UNITED STATES PATENT AND TRADEMARK OFFICE  
**CERTIFICATE OF CORRECTION**

PATENT NO. : 6,879,841 B2  
APPLICATION NO. : 10/086330  
DATED : April 12, 2005  
INVENTOR(S) : Ozluturk et al.

**FIG. 2**

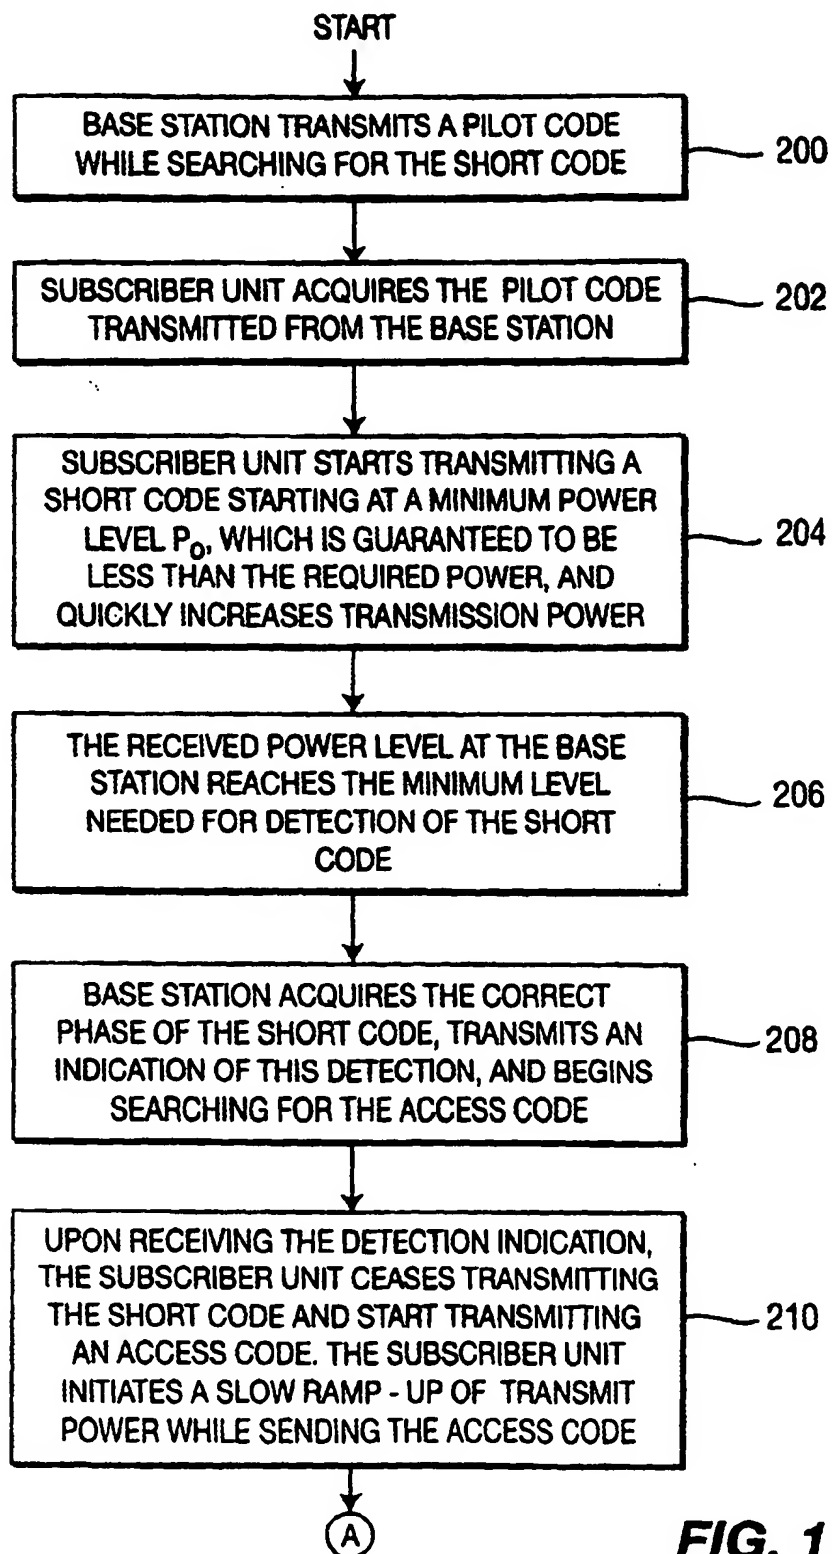
Please replace Figures 2, 11A, and 11B with replacement Figures 2, 11A, and 11B attached hereto.

At column 4, line 46, after the word "transmitted", delete "20," and insert therefor --21--.

At column 4, line 47, after the word "received", delete "22," and insert therefor --23--.

At column 4, line 48, after the word "signal", delete "20," and insert therefor --21--.
